#	Category	Location	Comment	Proposed resolution	GMV answer
1	major	5, p14 and general	<p>The conclusion reached in this document is not to externalize the representation information. ("it is concluded that the externalisation of the representation information is not recommended for SAFE")</p> <p>This is clearly in contrast to what has been discussed and agreed previously in the other meetings (SRR, PDR-C).</p> <p>If that is the case, then the remainder of the document could have been cut much shorter, and specifically the sections about the registry, etc., are not understood in this context. Specifically, all the section talking about the simplification, complete section 4, etc.</p>	<p>Discuss with all stakeholders and reviewers from the previous events (SRR, PDR-C), if externalisation shall be pursued or not.</p>	<p>Those sections about the registry were included trying to cover part of the PDR-C_A02 action: "...given the need to ensure at all times that links to representation information and auxiliary data are valid."</p> <p>In fact, we consider that the proposal of not going for the externalisation is due to the explanations and analysis included in this document. Therefore we

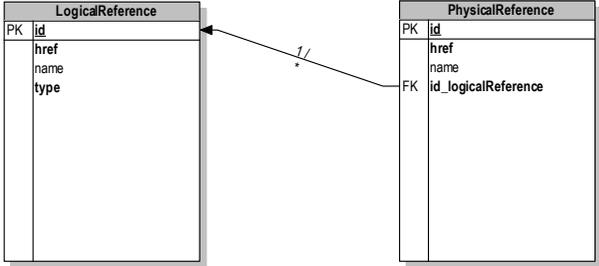
12	major	3.1.1.1, p19	<p>“For instance, in the database case, this would mean that the registry in this case will be a centralized database (that has to be preserved) with all the mappings between logical and physical paths stored.”</p> <p>The mentioned mapping should be part (black-box) of the archive system used and is IMO not a part of the SAFE standard; the “registry” should be disregarded, thus.</p>	Consider comment.	<p>Agree, the mapping should be part (black-box) of the archive system. However, the registry was introduced in this trade-off because it was needed to clarify how the externalisation worked, it means, how the references (logical and physical) between different SAFE Packages are resolved. As a consequence three different alternatives were analysed for this purpose.</p>
